APPLICATION NO.	FILING DATE	FIRST NAMED INVENTOR	ATTORNEY DOCKET NO.	CONFIRMATION NO.
10/813,036	03/31/2004	Toshiaki Takahashi	250464US6	3819
	7590 12/29/2006 AK MCCI FI I AND MA	EXAMINER		
OBLON, SPIVAK, MCCLELLAND, MAIER & NEUSTADT, P.C. 1940 DUKE STREET			KUMAR, RAKESH	
ALEXANDRIA, VA 22314		ART UNIT	PAPER NUMBER	
			3654	
<u> </u>				•
SHORTENED STATUTOR	Y PERIOD OF RESPONSE .	MAIL DATE	DELIVERY MODE	
3 MOI	NTHS	12/29/2006	PAPER

FINAL REJECTION

FIG. 23

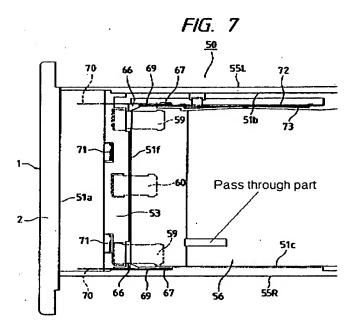
wherein the sheet feeding device further comprises: a recording media end detection member (see Figure 23) disposed at a position adjacent to a swinging side end of the stacking plate (56) and configured to contact the recording media stacked on the stacking plate (56; Figure 18A) and configured to be moved in a direction of a thickness of the recording media stacked on the stacking plate; and at least one pass-through part formed (see Figure 7) at the swinging side end of

wherein the recording media and detection member (Figure 23) is configured such that an end condition of the recording media in which all the recording media stacked on the stacking plate are fed out from the cassette is detected when the recording media end detection member falls into the at least one pass-through part.

Referring to claims 6,7,9,23,24 and 26. See above. Morinaga discloses the end detection member (see below Figure 23) contacts the topmost media sheet in the stack, the member connected by a shaft which rotates to designate a

depleting stack of media wherein an opposite end of a shaft connected to an indicator with marking to be relayed stack height to a processor.
